Addendum No. 2

Project	Stewart Homes Pickering Renovations 1907 Valley Farm Road, Pickering	Reference:	Building Department Upgrade & Miscellaneous other items
		Issue Date:	June 18, 2018

Project No: 1711

"Shorty" Catch Basin

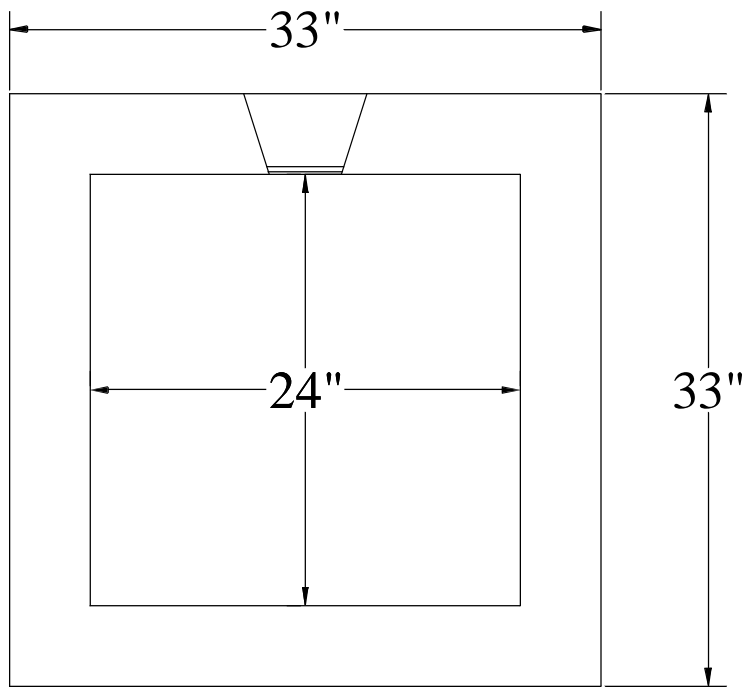
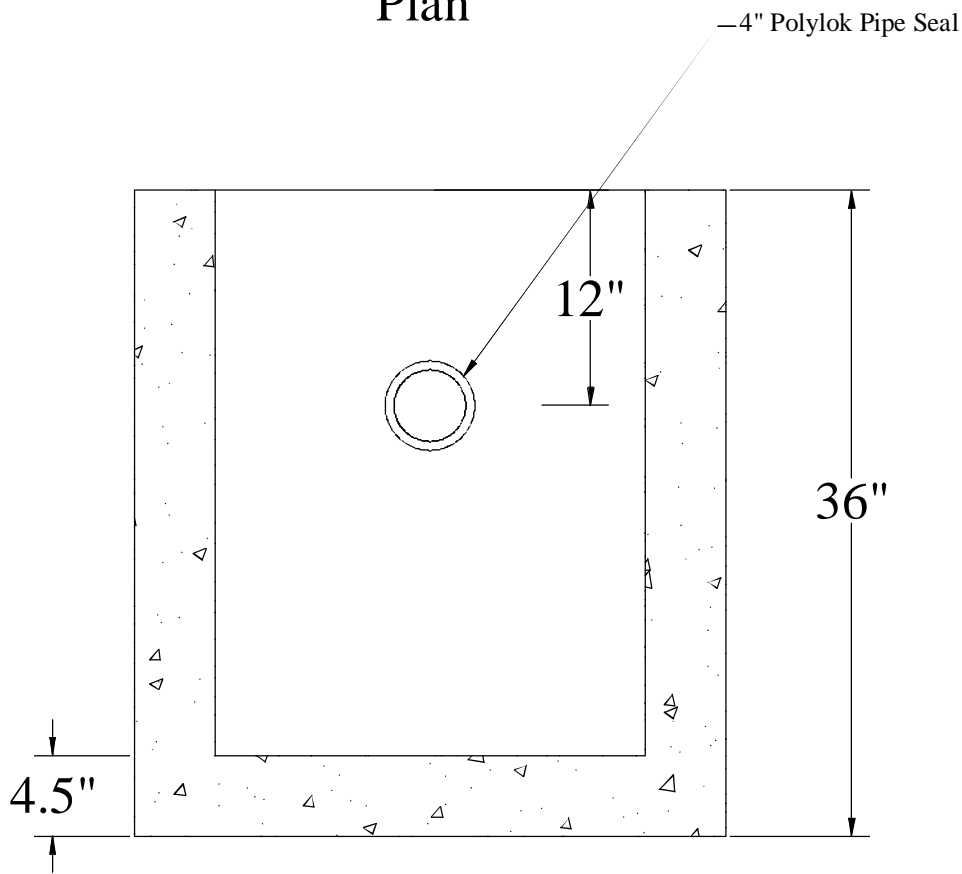
9. Supply & install new catch basin at back of house:
Based on draining the patio and half of the roof, a catch basin should be installed as per the attached sketches, available from Acton Precast Concrete, Acton ON, complete with a standard steel grate.
The invert level will be 97.0m
The pipe will be 4" PVC equal to IPEX BDS
Pipe slope to be 1.5%
Pipe run to be approx 120' or 36.5m
Invert at connection to storm drain = 97m- .55 = 96.45m minimum. If available fall is greater, slope the pipe at a higher incline along the run. Field check storm drain connection elevation before construction.
All elbows to be 45 degrees maximum.
Install clean out.
Contractor may substitute a "plastic" catch basin, by "ReIn" or "Stormdrain" with equal capacity for the above concrete catch basin.
